CONSTRUCTION PLANS FOR

PROJECT NO. TS01-20 (SHEETS 1 THROUGH 25)

AS-BUILT NOTES

BERNALILLO COUNTY PUBLIC WORKS DIVISION TECHNICAL SERVICES			
TITLE: FOOTHILL/BRIDGE INFILL AREA SEWER AND WATER IMPROVEMENTS CONSTRUCTION NOTES, LEGEND & INDEX OF DRAWINGS				
Design Review Committee	City Engineer Approval	Last Design Update	Mo./Day/Yr. 	Mo./Day/Yr.
City Project No. 747881		Zone Map No.	Sheet	of 25
County Project No. TS01-20

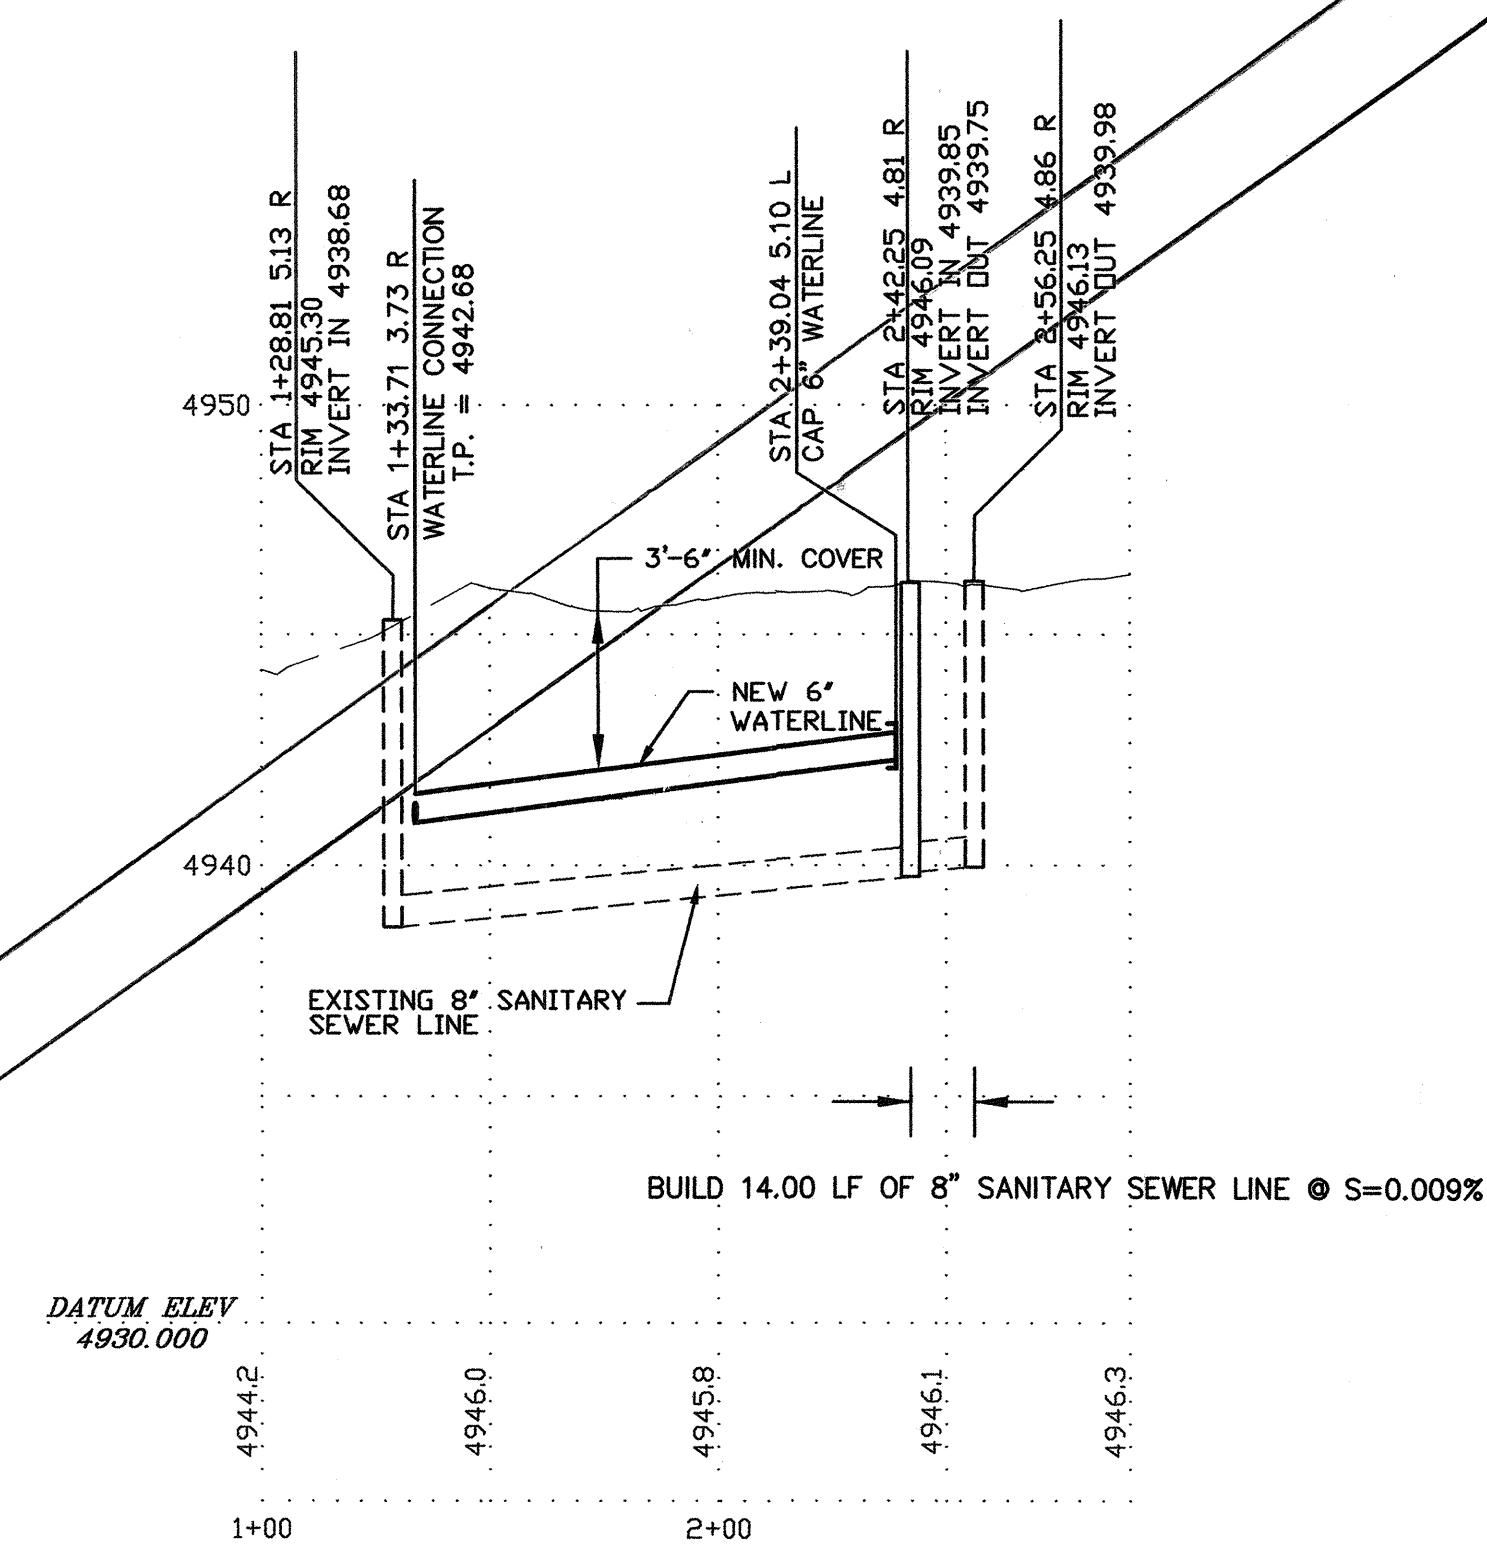
REPLACE SEE NEXT SH.

AREA 422 - PRIVATE ROAD PLAN

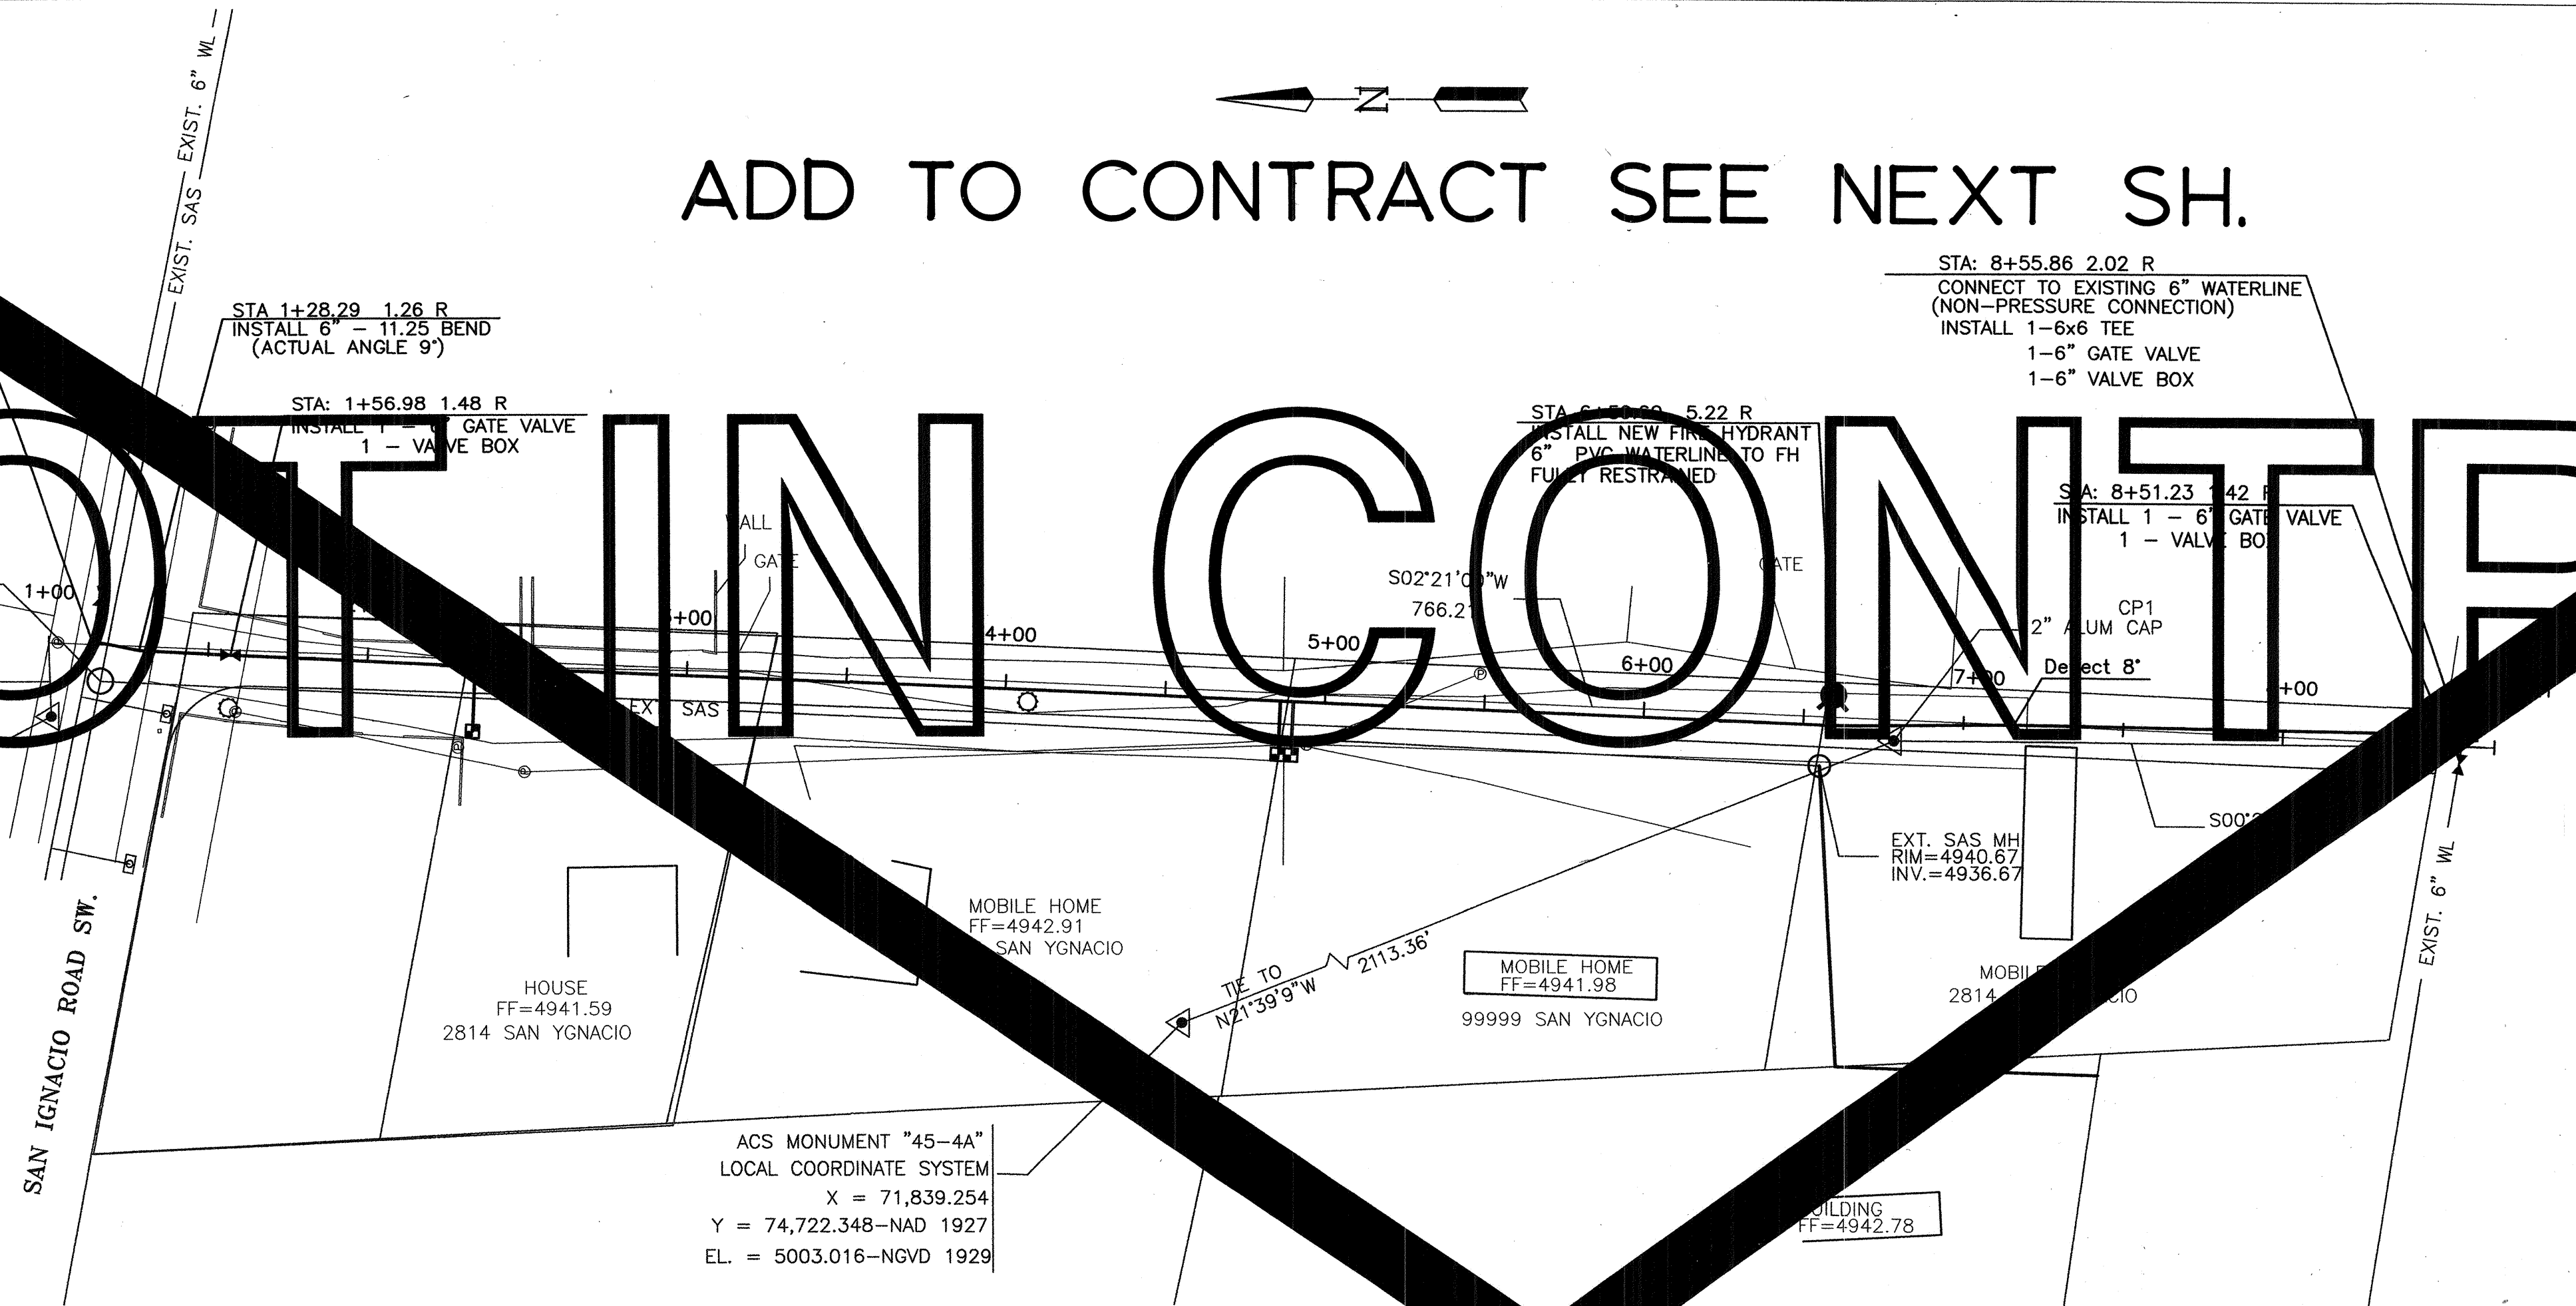
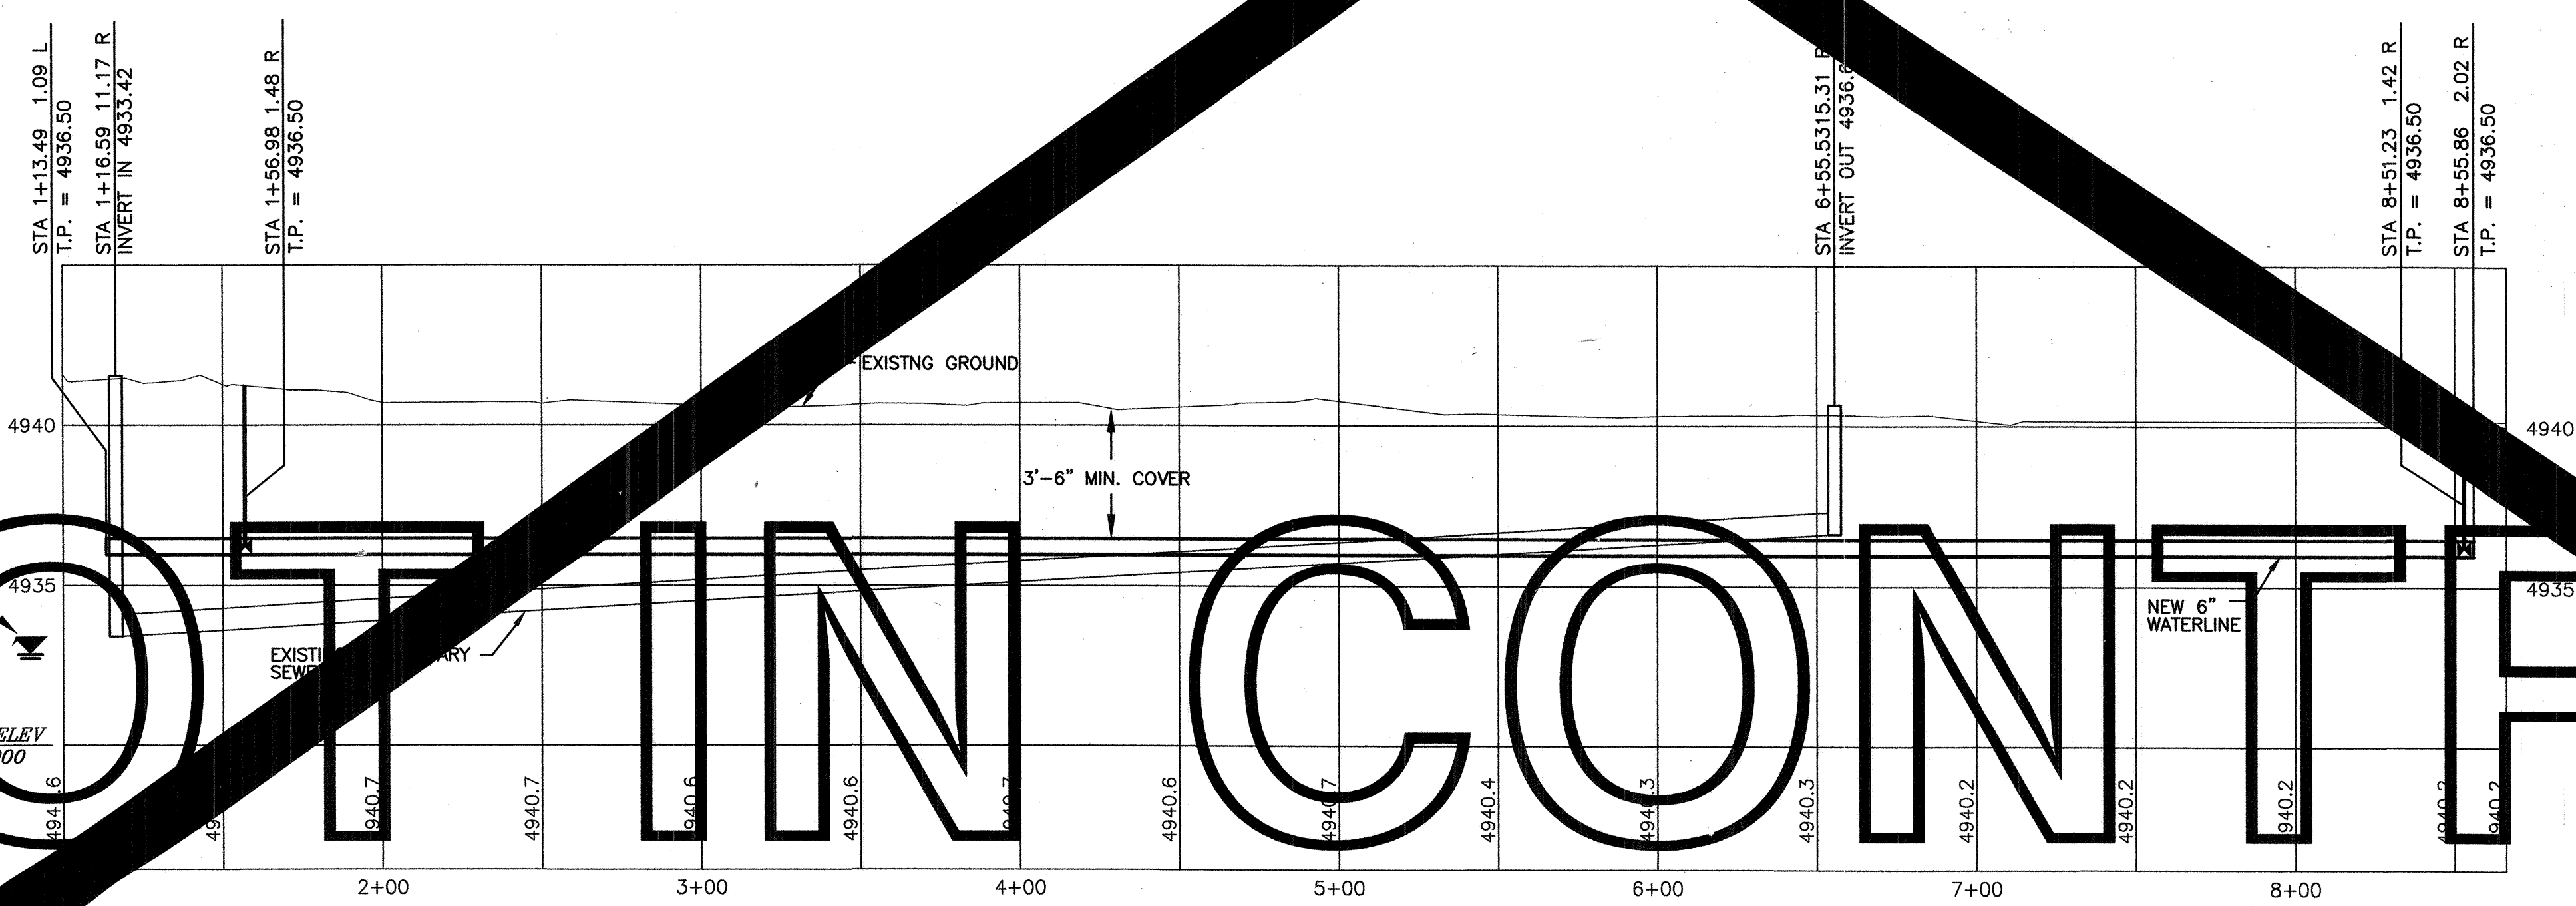
ADD TO CONTRACT SEE NEXT SH.

AREA 426 - PRIVATE ROAD PLAN

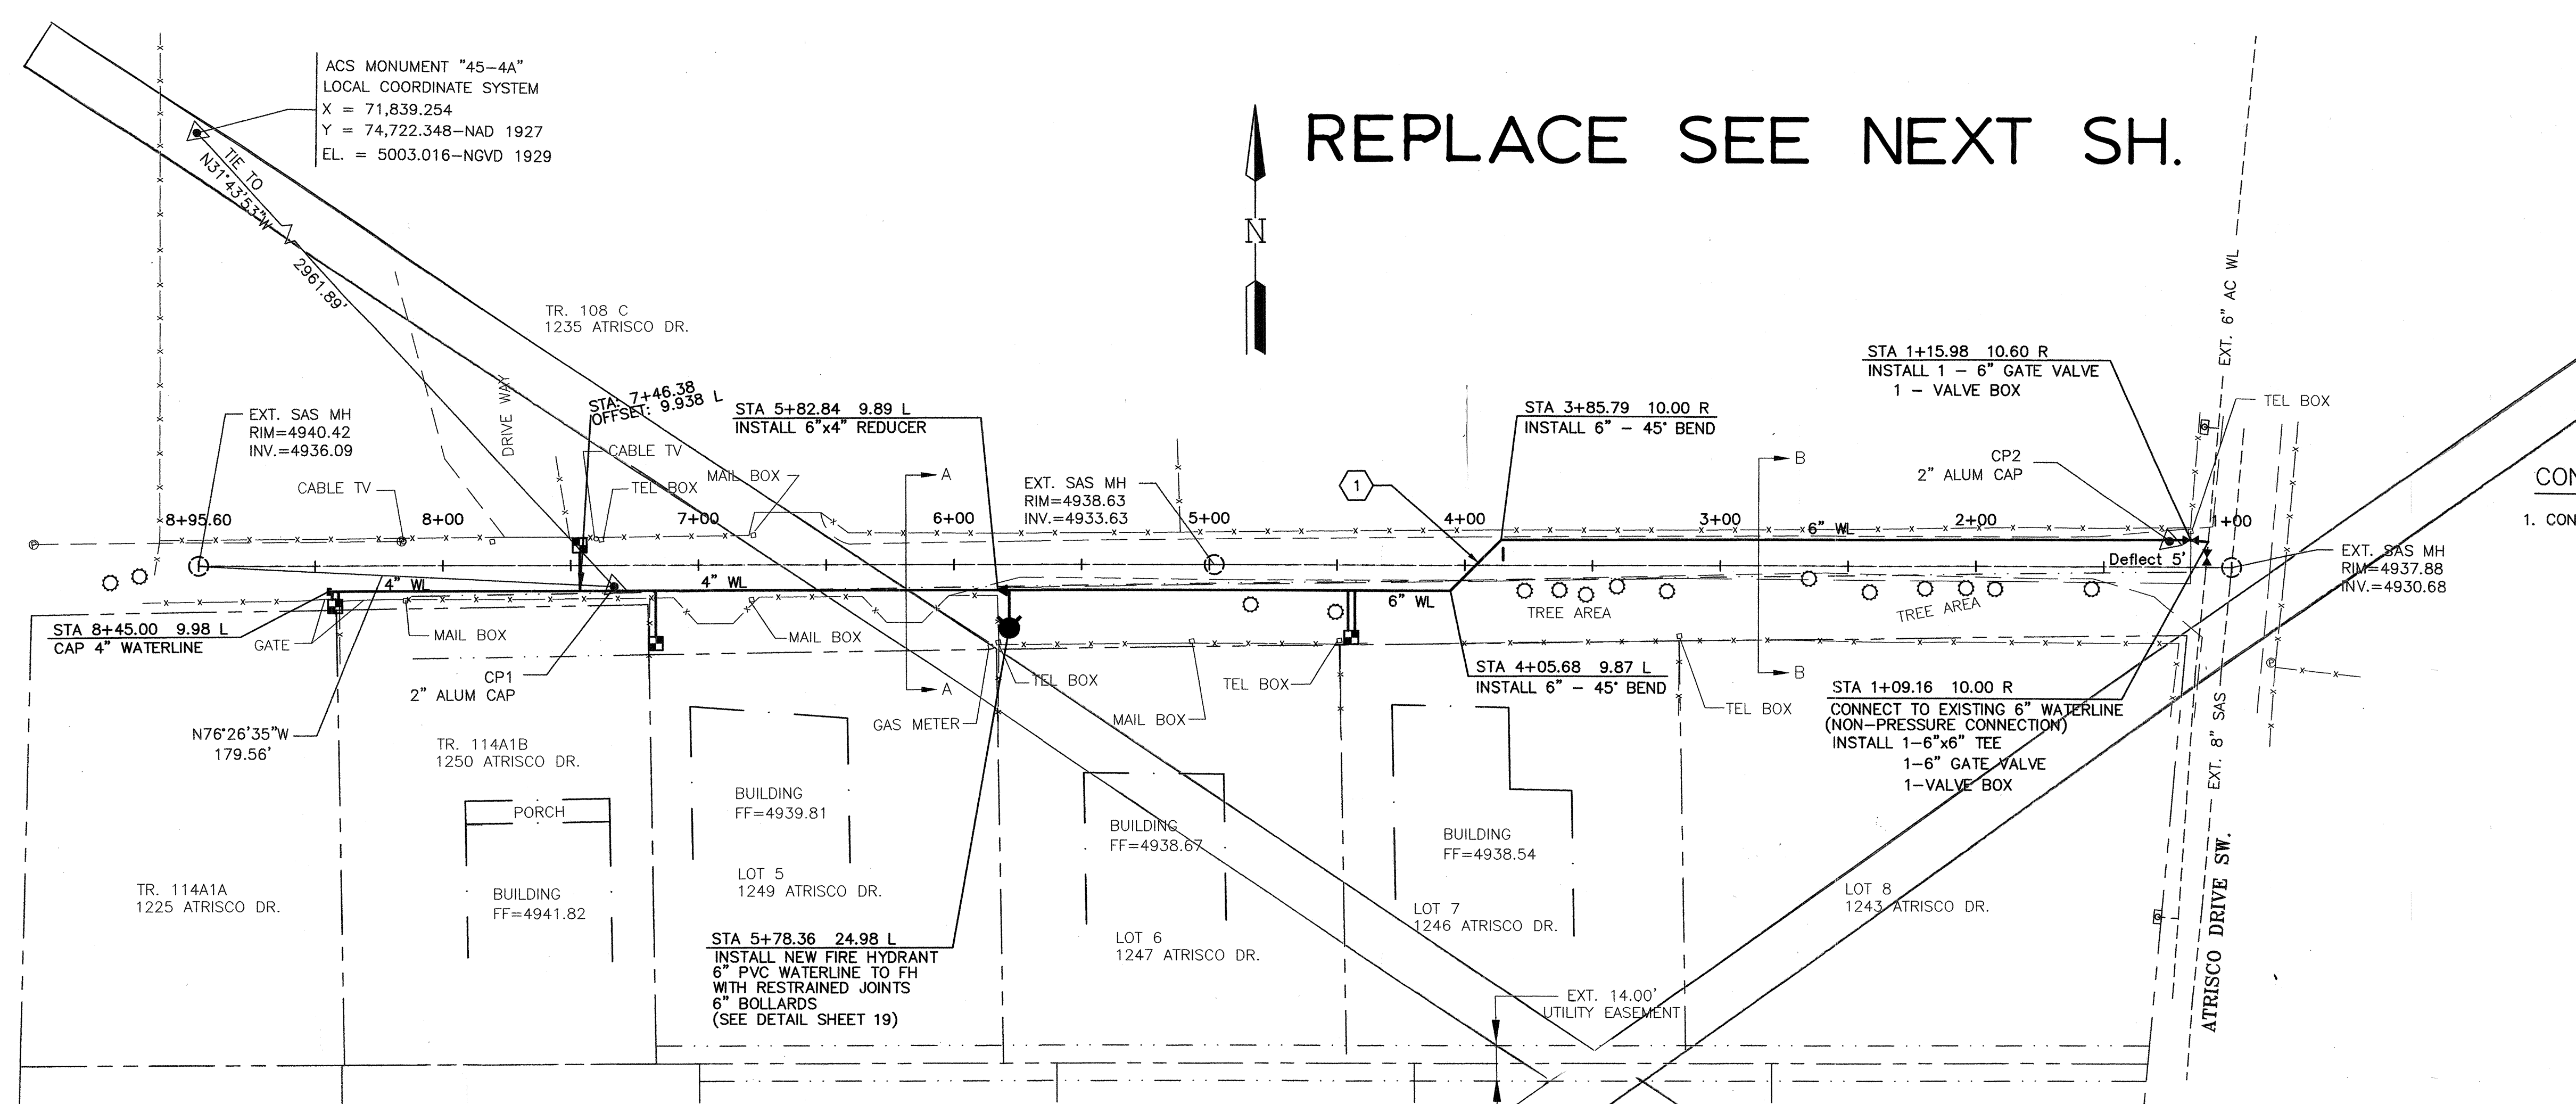
REPLACE SEE NEXT SH.
